Product Change Notification

1. ECR #: 213026
Notification #: 629

3. Series:
• LPAF - LPAF SOCKET ASSEMBLY

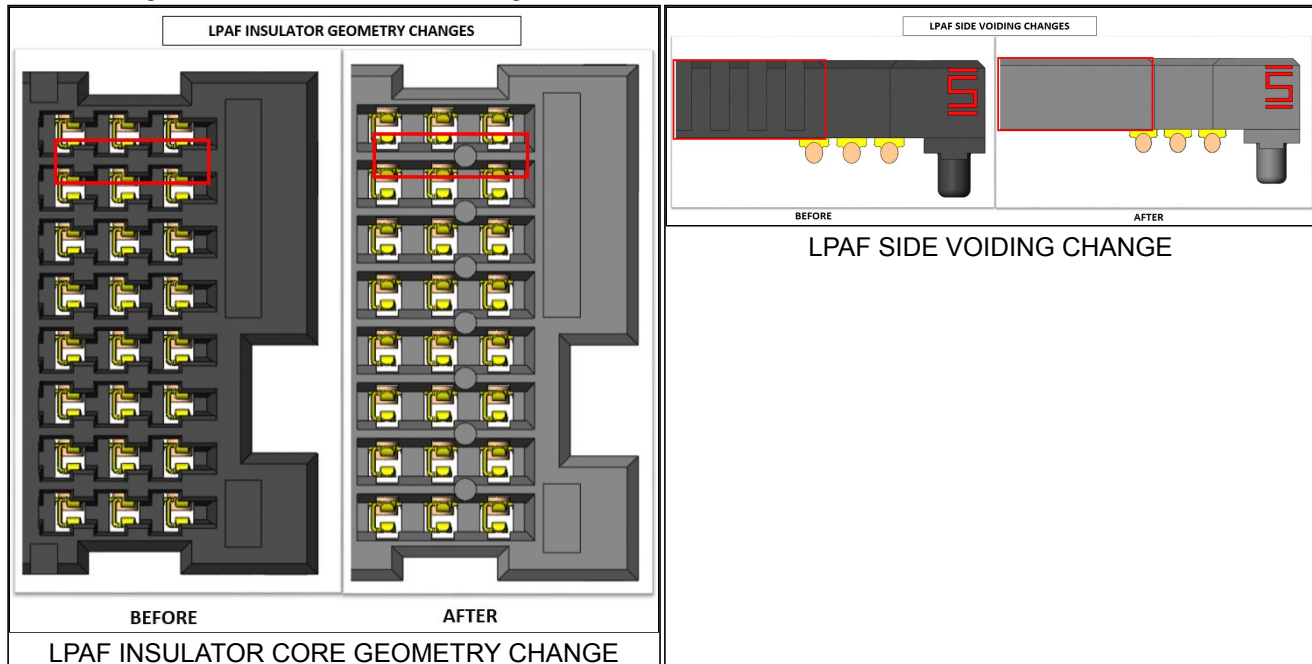
5. Description of Change:
Mating side insulator core geometry and side voiding changes. The cores will go from a T shaped core to a rectangular shape and the side walls will go from ribbed to smooth.

6. Method of Identifying Change
Visual, changes will be visible under 10x magnification.

7. Reason for Change:
Both the insulator core geometry and side voiding changes were to improve the manufacturability of the connector. This is being modified as a rolling change. Old and new revisions of material may be received until change is complete.

- Function - These changes will not affect mechanical or electrical integrity of the connection, no change to function.
- Fit - No change to the fit. These changes are backward compatible with existing LPAX.
- Form - Mating-side insulator core geometry was modified to improve the manufacturability.
